2022-02-04 UPDATE

This first part of this document contains a quick comparison between the 2022-02-04 version of the model and the 2021-11-10 version of the model.

Figure 1: Daily Total Volume Difference v8.3.2 2022-02-04 vs v8.3.2 2021-11-10.

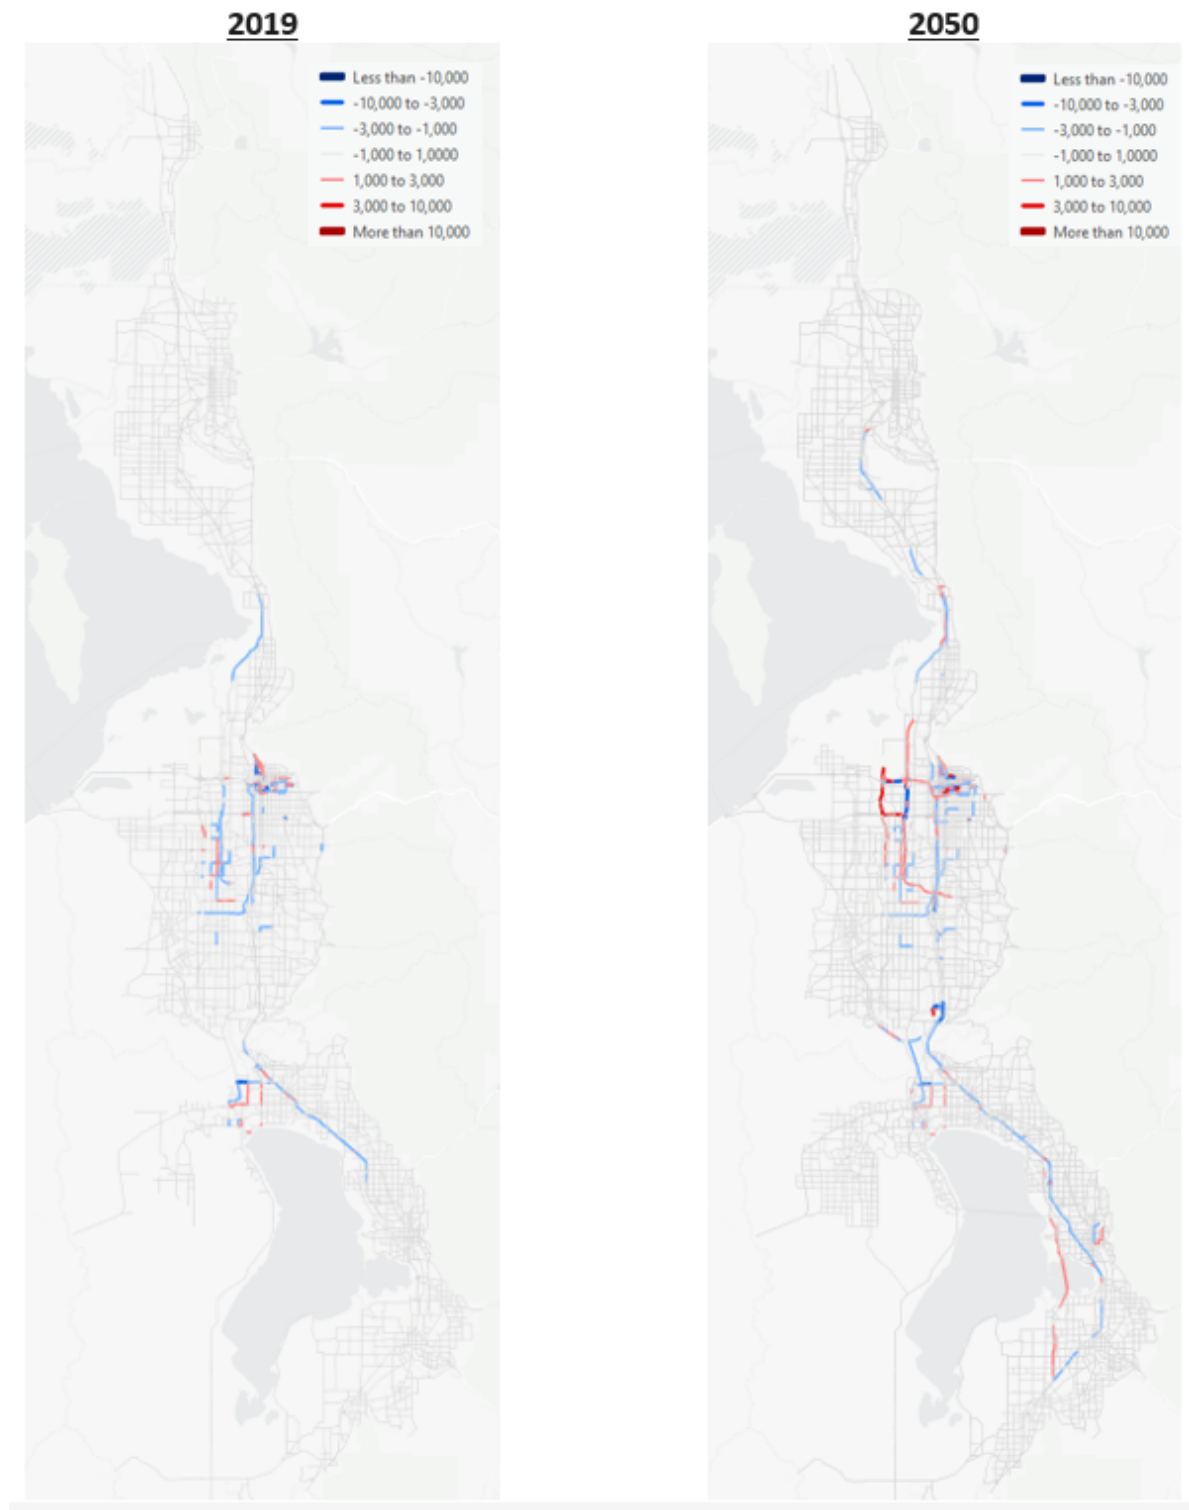
Figure 1 and Figure 2 contain a daily total volume comparison and a daily truck volume comparison. Daily total volumes are very similar between the two models. There is a slight shift of volume off of I-15 and onto parallel corridors. The largest volume shifts in 2050 are between I-215 and Bangerter Highway. Figure 1 shows one-way volumes.

Figure 2: Daily Truck Volume Difference v8.3.2 2022-02-04 vs v8.3.2 2021-11-10.

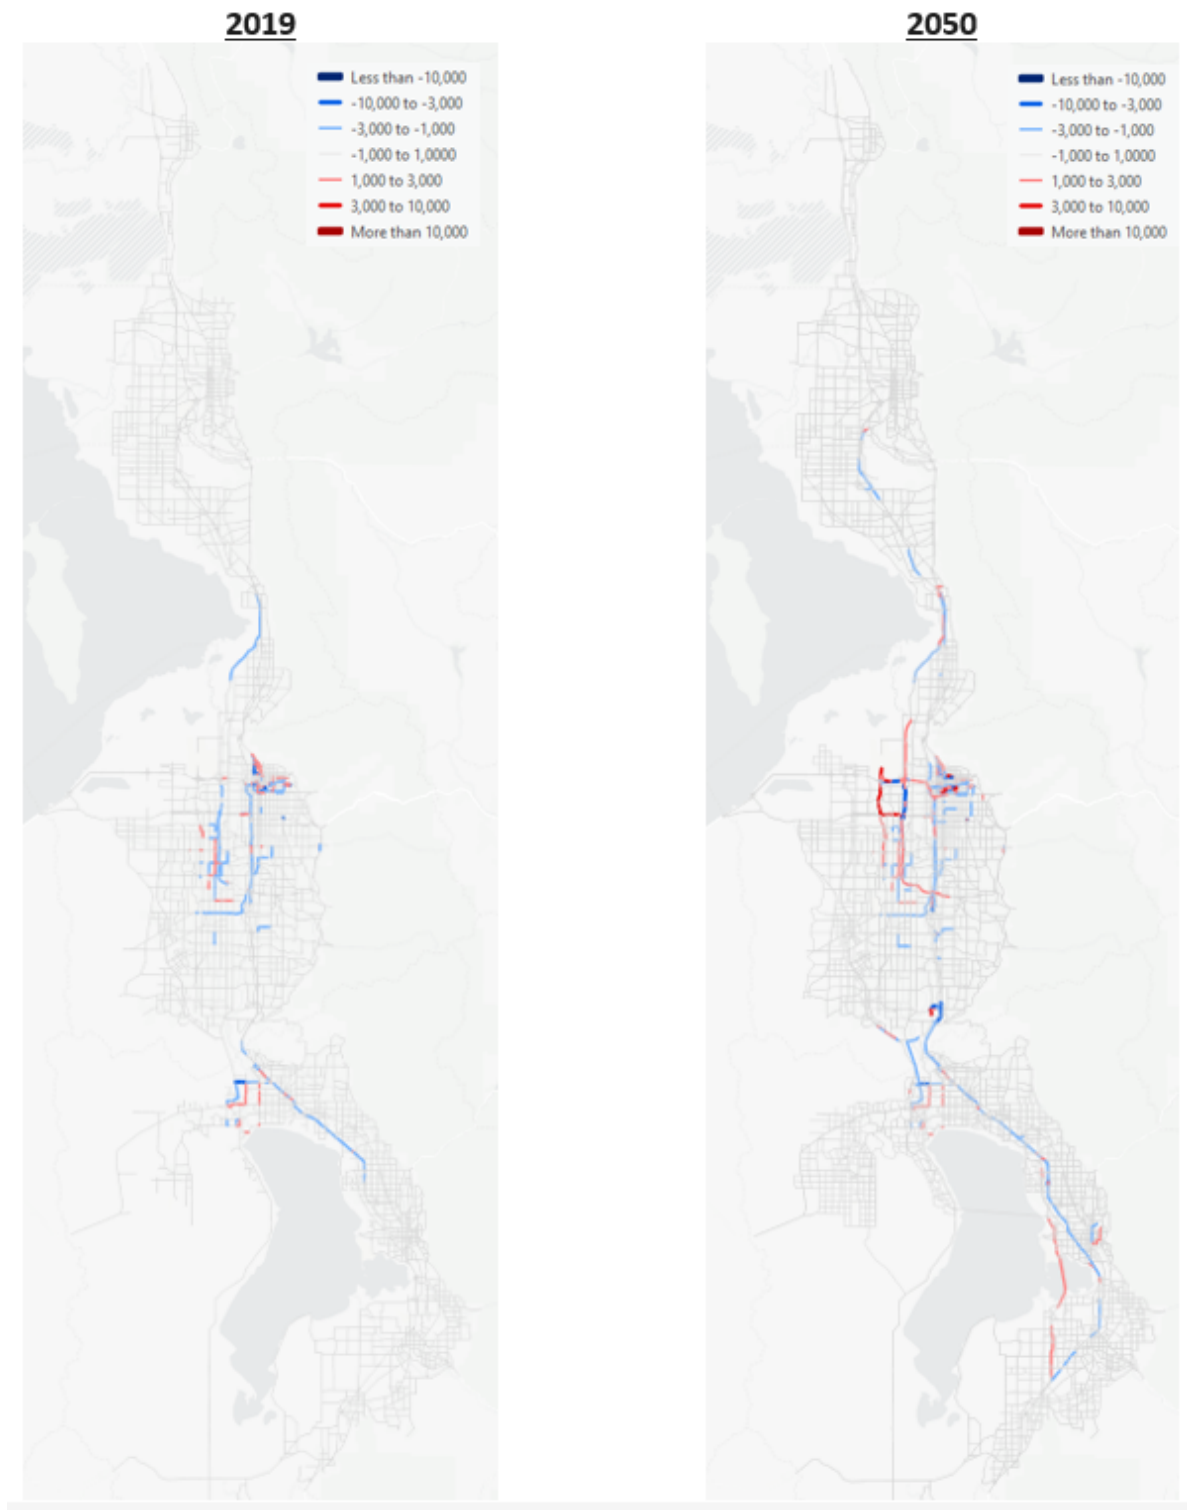
Daily truck volumes show more differences with volumes dropping between the two models. The drop in volumes is less than a 1,500 trucks per day on freeways but is widespread throughout the region. Figure 2 shows one-way volumes.
